Driver Seat - LH Rear Bolt Cover Deformation

YEAR(S)	MODEL(S)	ADDITIONAL INFORMATION
2014	Tundra

Some 2014 model year CrewMax and Double Cab Tundra vehicles may exhibit a condition where the driver's left rear seat track cover is being caught by the seat side shield, causing the seat track cover to bend backwards when the seat is in the rearmost position. Follow the procedures in this bulletin to address this condition.

Figure 1. Front Seat Cushion Shield LH

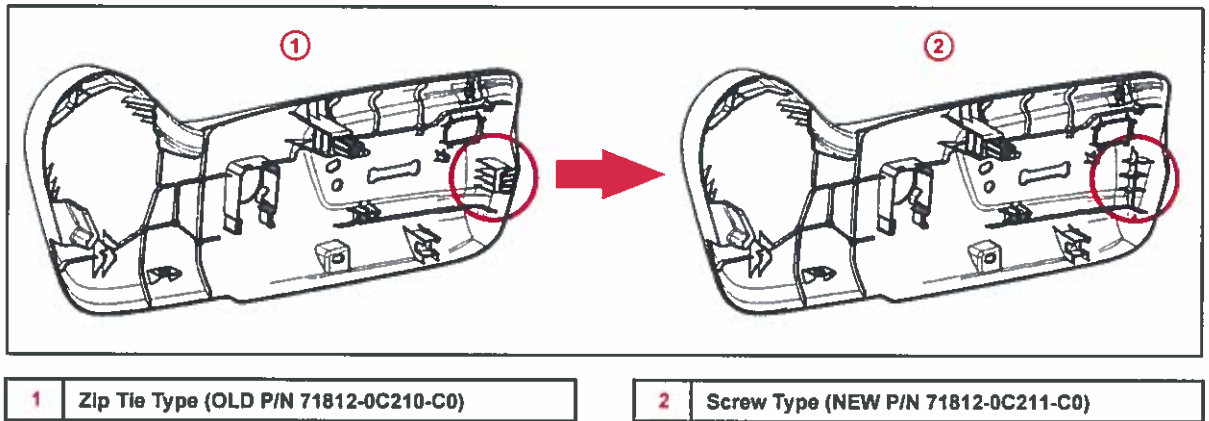
2. Replace the original Front Seat Cushion Shield LH (zip tie type) with the NEW Front Seat Cushion Shield LH (screw type) and Front Seat Cushion Shield Wire LH.

Figure 2.

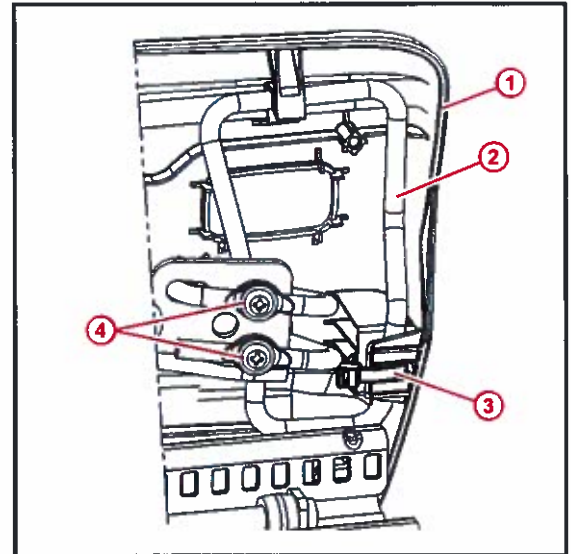
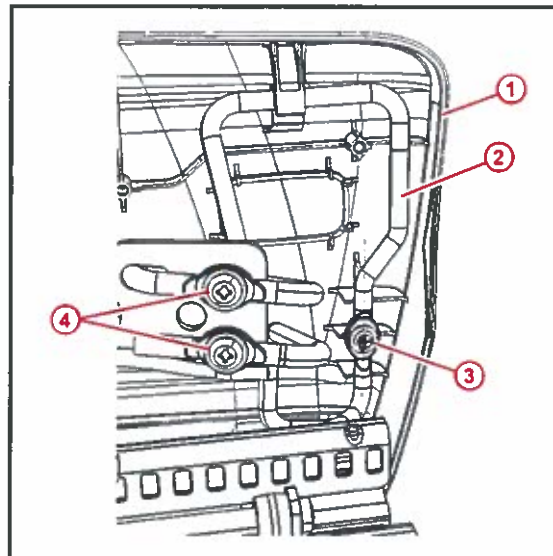
A. Remove the side shield (zip tie may be cut).

B. Remove the Front Seat Cushion Shield Wire LH from the frame by removing the 2 wire attachment screws.

- C. Attach the NEW Front Seat Cushion Shield Wire LH.

- D. Attach the NEW side shield screw.

Figure 4.

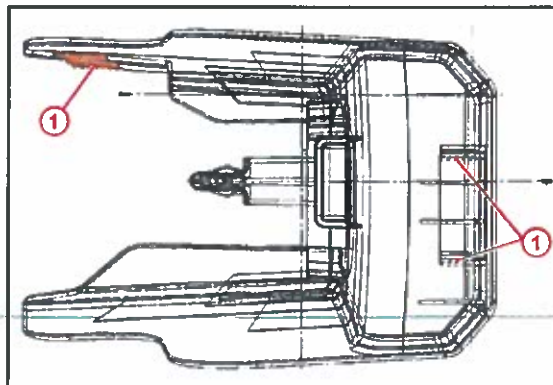
3. Replace the original Outer Rear Seat Track Bracket Cover LH with the NEW Outer Rear Seat Track Bracket Cover LH.

The rib on the new cover is longer than the original part by 15 mm.
